FARRAGUT VISUAL RESOURCES REVIEW BOARD AGENDA

Farragut Community Center
Large Classroom
Tuesday, February 25, 2025
6:00 p.m.

MEMORANDUM

TO: Farragut Visual Resources Review Board
FROM: Bart Hose, Assist. Community Development Director
SUBJECT: Scheduled Meeting - Tuesday, February 25, 2025, at 6:00 p.m.

CUS-SIGNEXAMPLE OF
PUSH THRU
ACRYLIC**SHOWN SQ FT OF SIGN #1: 39.6875 SQ. FT**
SQ FT ALLOWED: 40 SQ. FT FOR MONUMENT

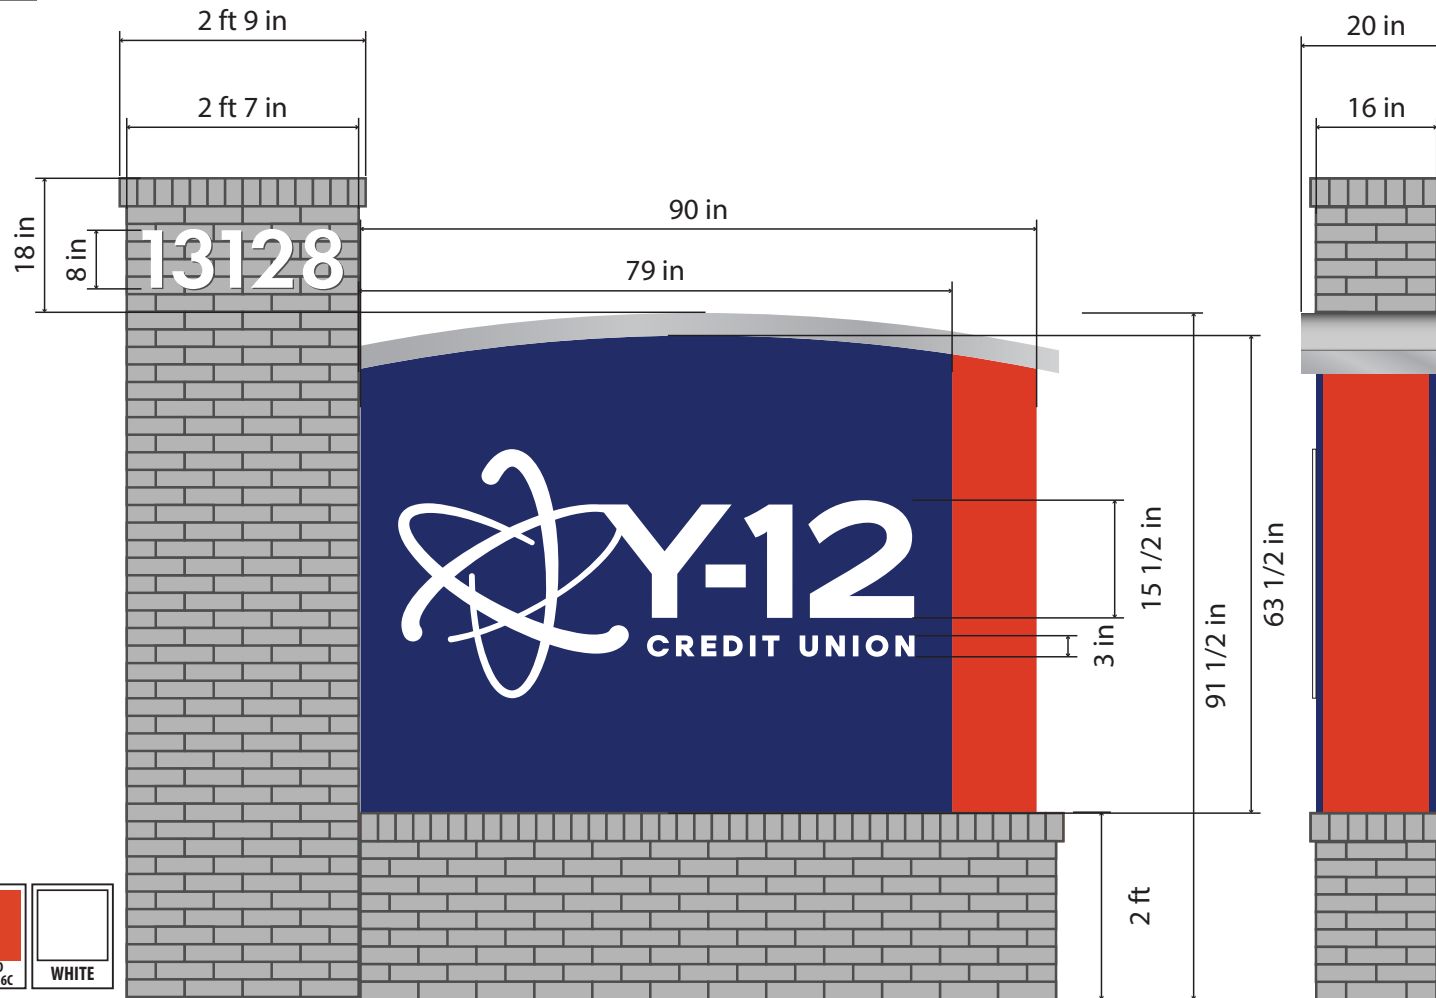
Y-12 Credit Union is requesting approval to replace and upgrade the permanent ground mounted sign at their facility located at 13128 Kingston Pike.

The existing sign setback is 20 feet, and the proposed sign face area is 39.69 square feet and 91.5 inches tall. The applicant will need to ensure that a minimum 20-foot setback is maintained to avoid compliance issues. The sign is internally lit and includes the required 2-foot-high base and address numbers. The existing landscaping will need to be verified and upgraded if necessary to meet the current standard. The staff can recommend approval subject to the landscaping being upgraded if necessary.

LA5.00

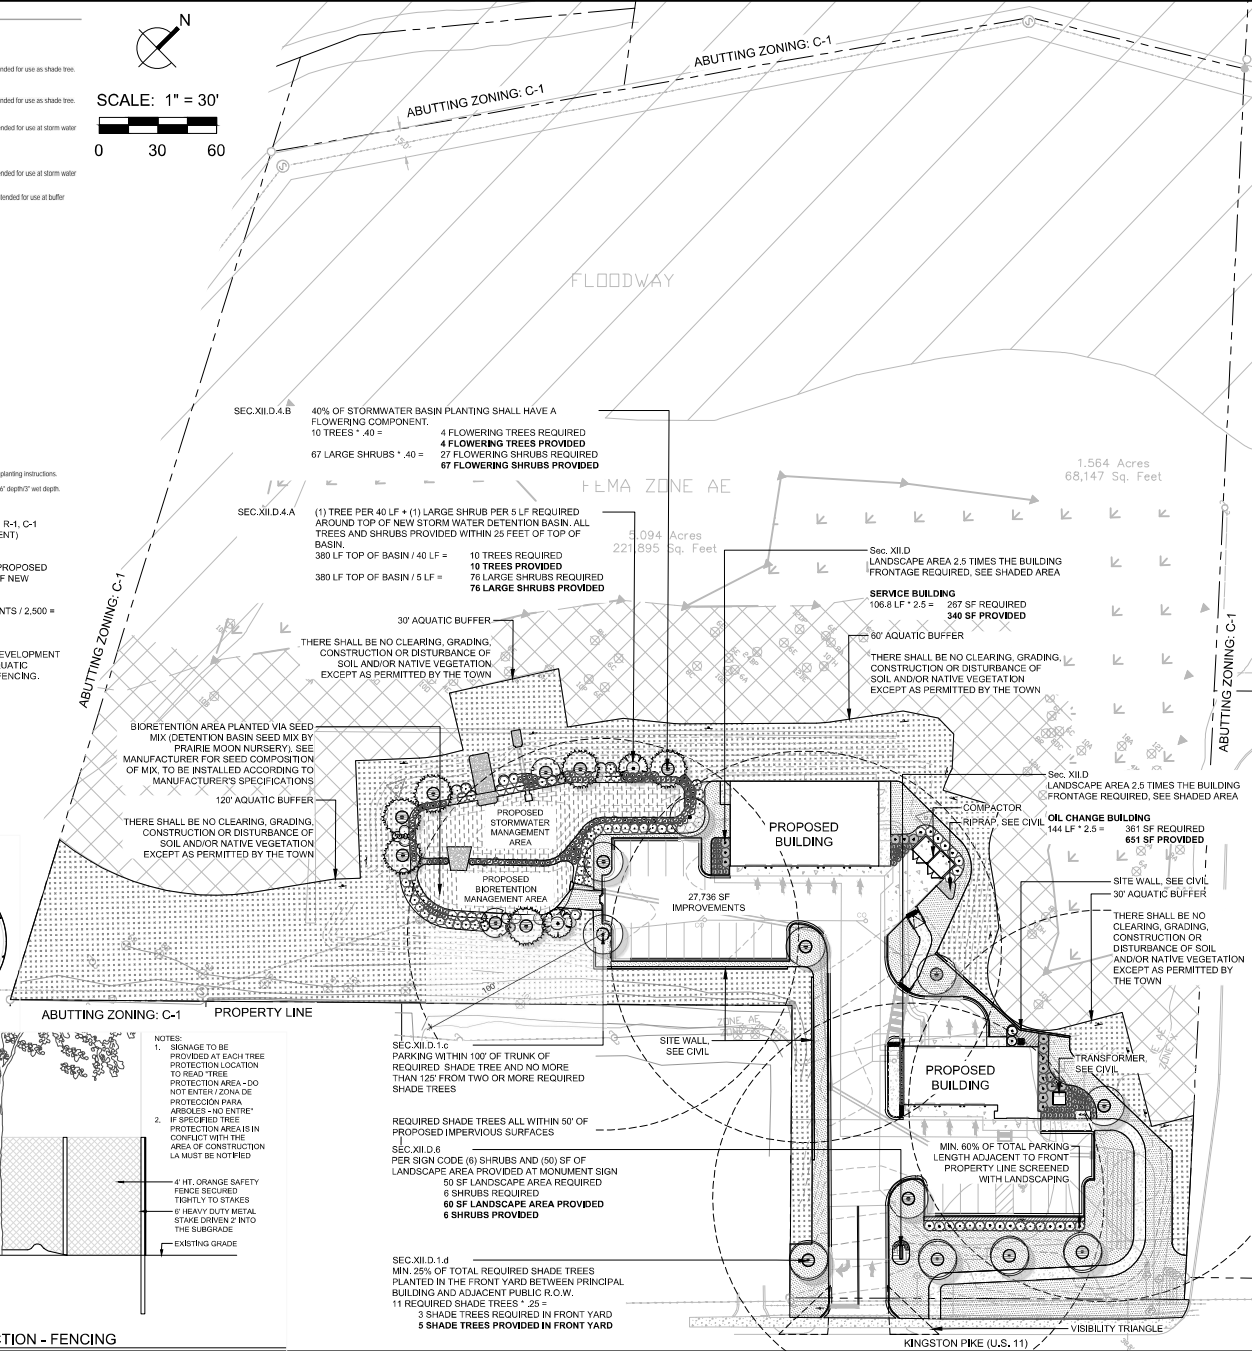
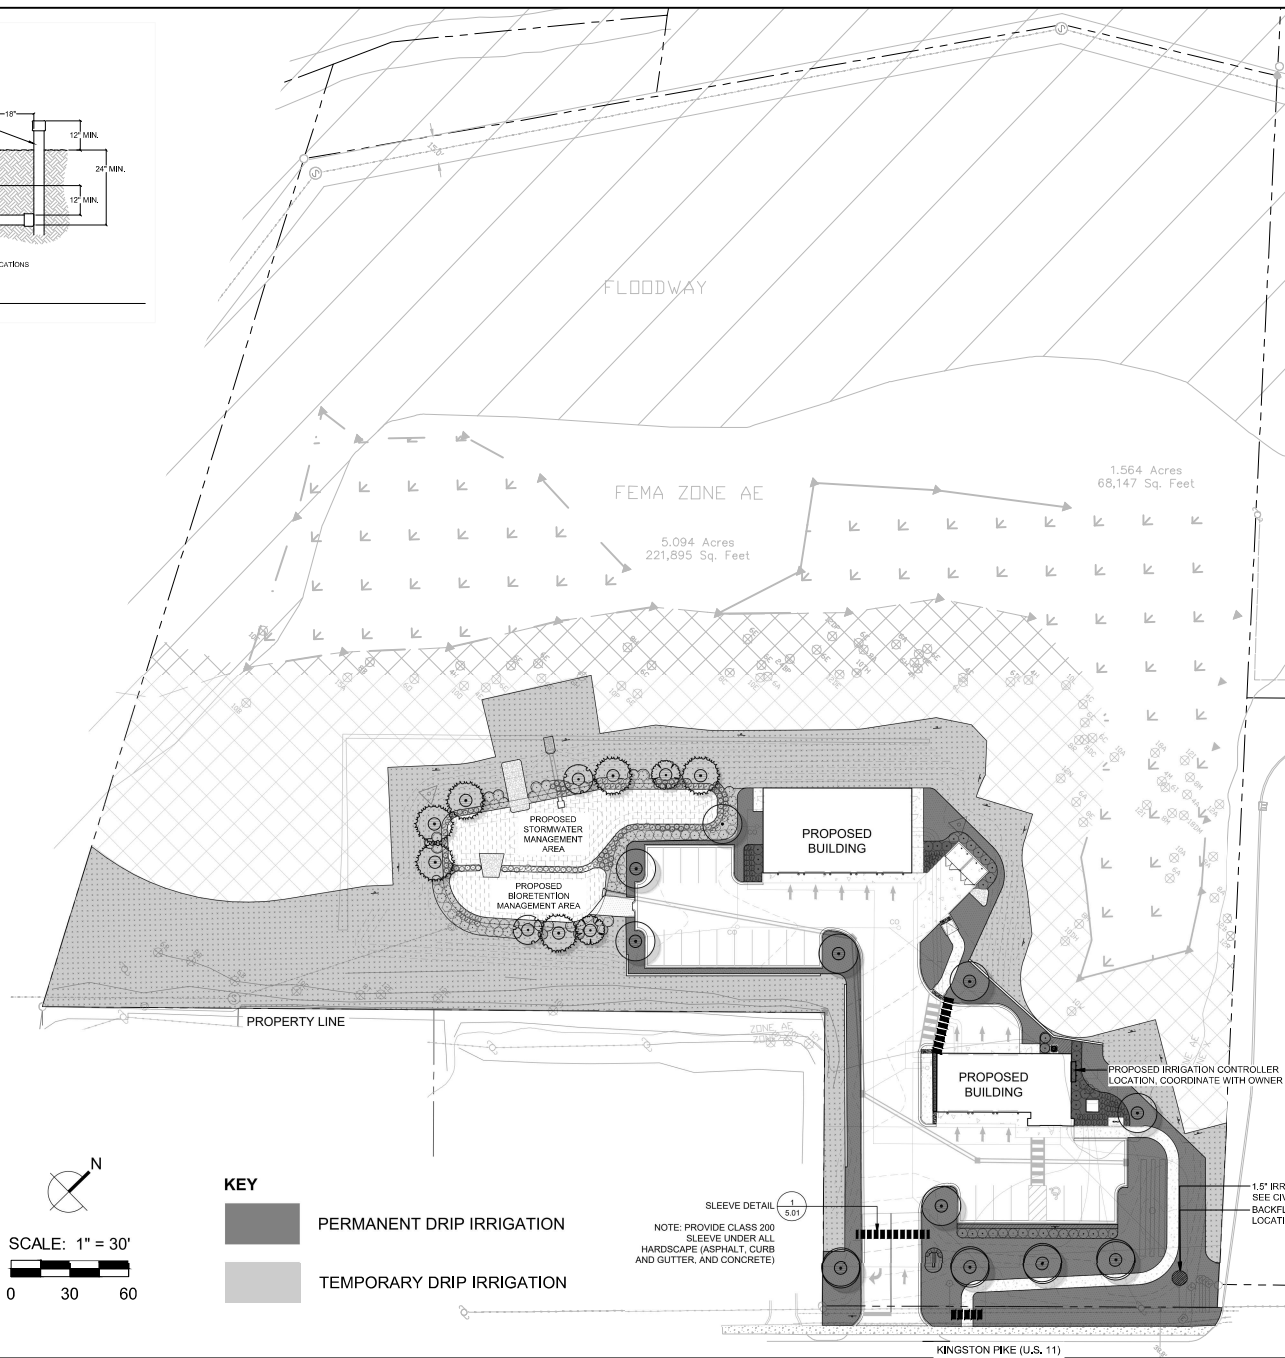
This item involves a landscape plan for a new Express Oil Change & Tire Engineers facility being developed off Kingston Pike.

The plan includes required shade trees, landscaping between the building and parking lot, and detention basin related landscaping. It also includes a stormwater bioretention feature. The plan meets the Town's minimum standards and staff can recommend approval.

L2.1

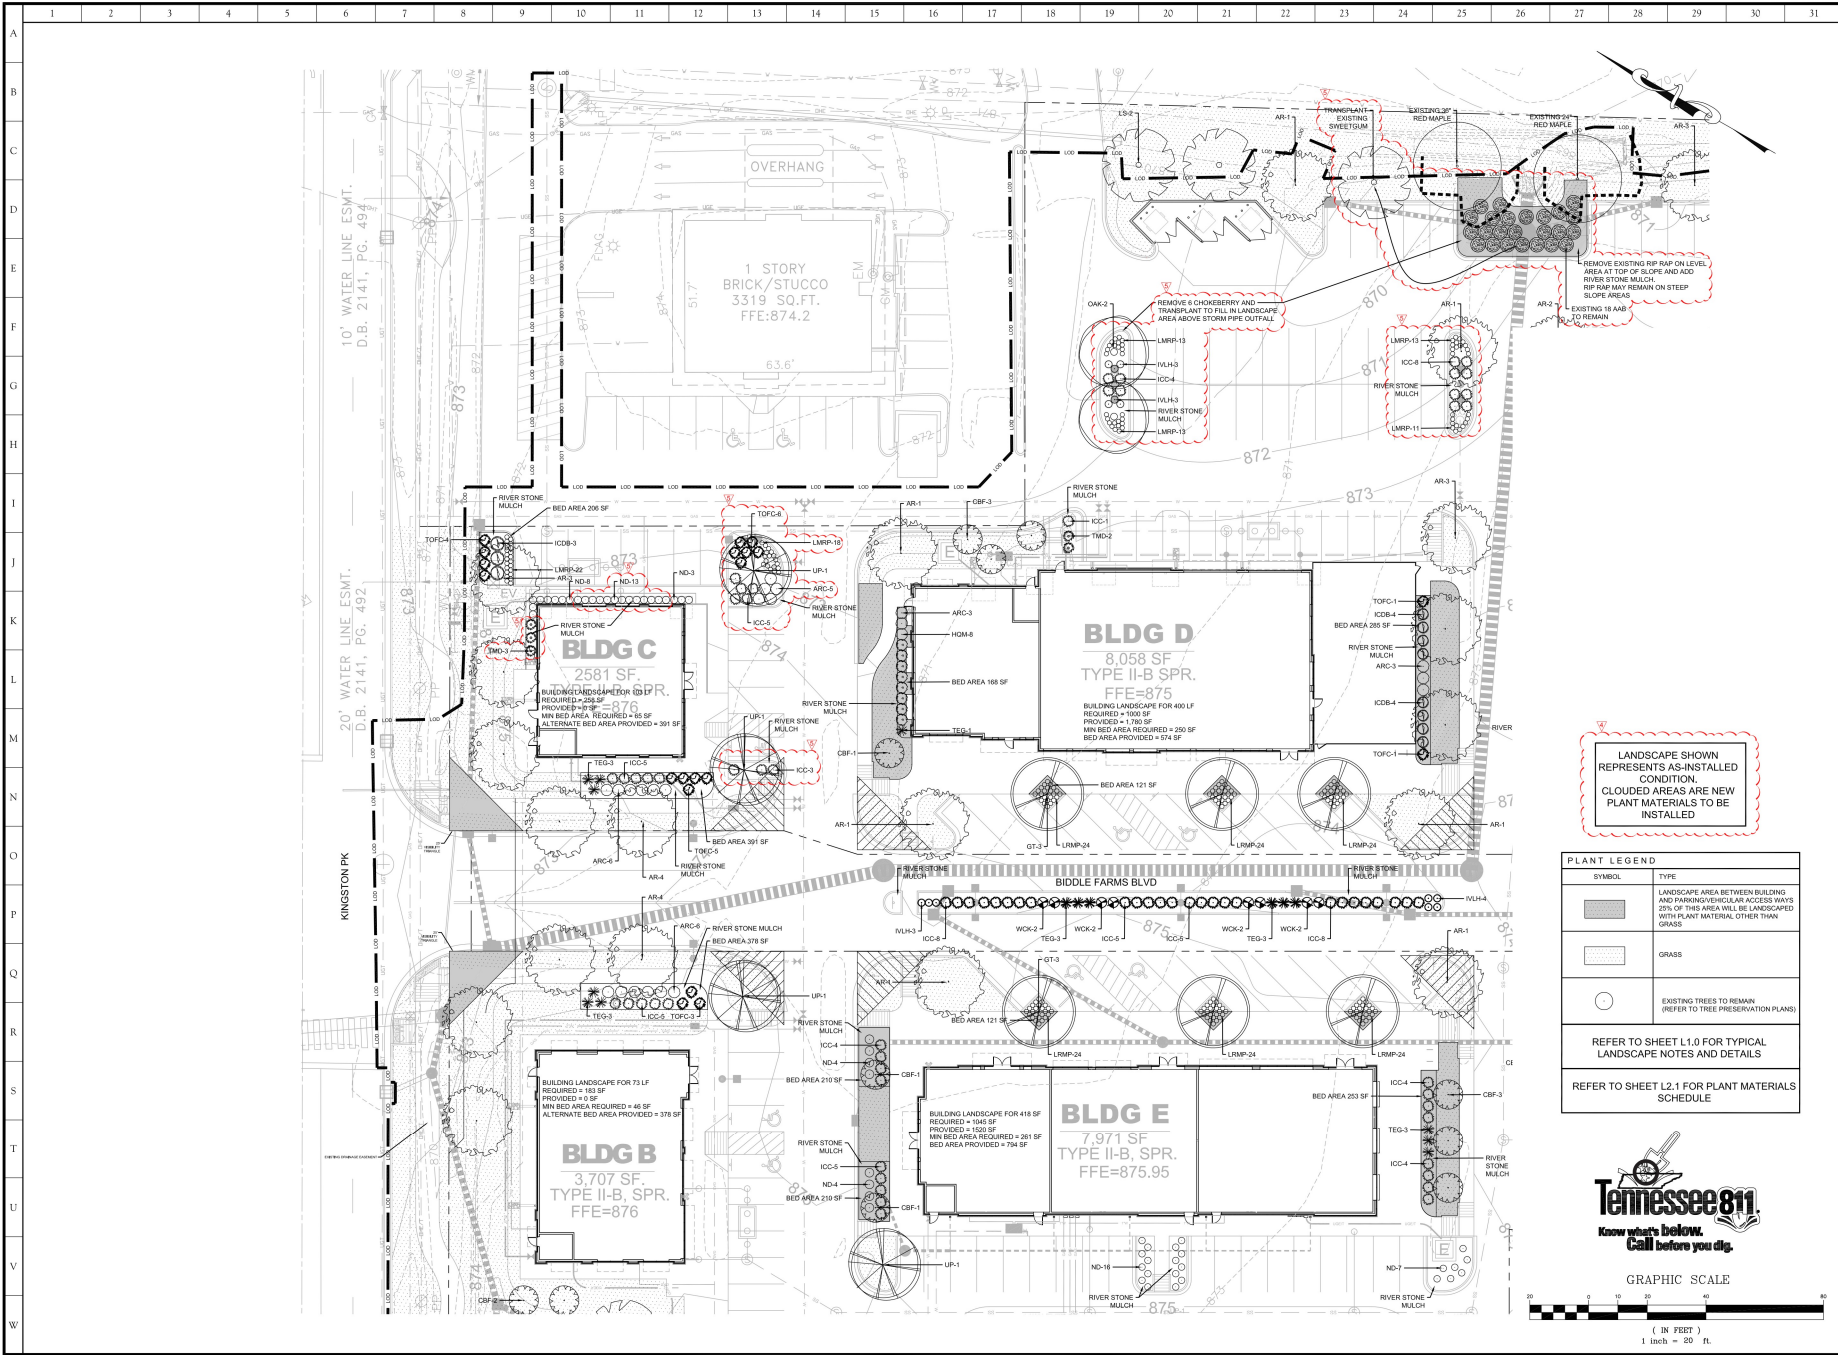
This item involves a revised landscape plan for the commercial, Phase II, section of the Biddle Farms development. It includes both as-built landscape updates and proposed revisions and is primarily shown on plan sheets L2.1, L2.2, and L2.3. Portions of the plan were reviewed and approved last month but there were additional revisions needed to address the use of river rock within the parking lot islands and some permitter areas.

The revised plan incorporates additional plantings within the parking lot features to soften and improve the appearance of the river rock hardscape elements. The Board will need to review these revisions to determine if they satisfy the Town's applicable requirement, which is listed below:

Mr. LaCroix made a motion to require the applicant to revise the plan to: 1) add plantings and/or lawn areas to the parking lot islands and perimeter strips to soften the appearance of any stone hardscaping used; 2) evaluate irrigated areas to ensure plant survival where stone cover is used; 3) ensure similar river rock is used in all stone covered areas and replace the existing area of larger rip-rap stone; and 4) soften the transition between Phase II and Phase I (Aldi), which incorporated lawns with trees and shrubs in and around parking lot features. The motion included resubmitting the plan for Board review. Mr. Russ seconded the motion, which passed unanimously.

LANDSCAPE SHOWN
REPRESENTS AS-INSTALLED
CONDITION.
CLOUDED AREAS ARE NEW
PLANT MATERIALS TO BE
INSTALLED
